**Planning Application Ref 21/01281/RM Land west of Cheltenham Road, Evesham**

We wish to register an objection to this application by Bloor Homes.

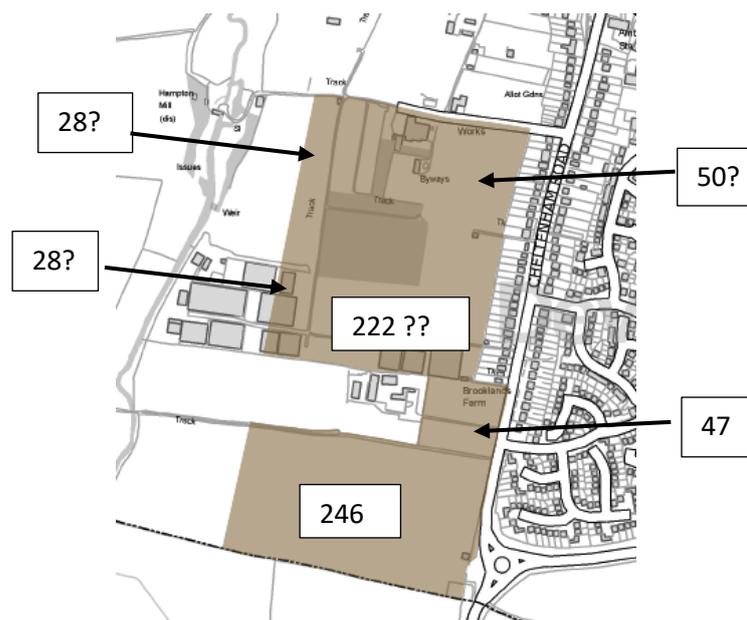
The allocation for this area in the Adopted SWDP is for 500 units; the allocation is shown below. Already 47 have been built at Brooklands Farm and a further 246 under construction in Phase 1 by Bloor Homes. Phase 2 is proposed now to be 222 units, i.e. a total of 515. This number omits two areas shown for future development; one in the west of Phase 2 and one to the west of the employment site to the north. Both of these are indicated as having potential for 28 each i.e. 56 in total. In addition, the land east of the employment site is included in the allocation, and is sufficient in area to accommodate another 50 units. This will result in a total of **621 units** not 500.
